## Topic: RTK Pan Gasket Thickness Improvement

### PRODUCT IMPROVEMENT: TRANSMISSION GASKET THICKNESS

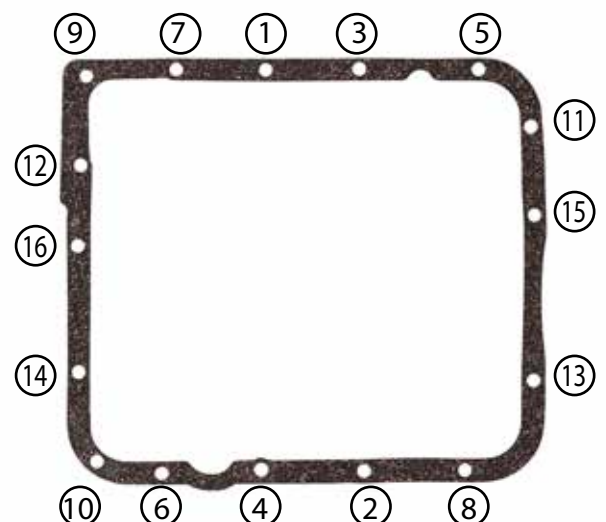
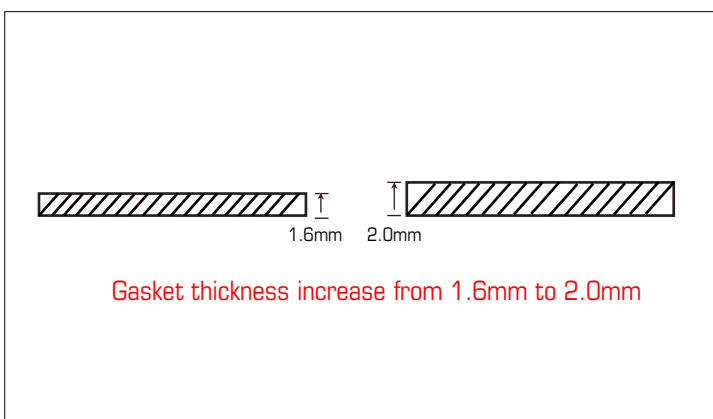
Following this process we identified the potential risk of damage to the pan gasket if the wrong tightening force and sequence was applied causing the gasket to split on one end and therefore a fluid leak would occur. We have increased the thickness of our gaskets to 2.0mm ensuring potential risk is further minimized.

This improvement has been made to all our existing Transmission Part Numbers and is a rolling change. Some product in the market will have the 1.6mm gasket until new stock cycles through the distribution channels. There is no issue fitting this gasket however attention needs to be taken to ensure that the transmission pan is not deformed or bent, the gasket flat surface is clean from any old residue and lastly that the correct tightening torque and sequence is followed.

The new gasket will be more forgiving in case of over tightening, and it is strongly suggested that the manufacturers torque specs are followed to ensure no fluid leaks after installation.
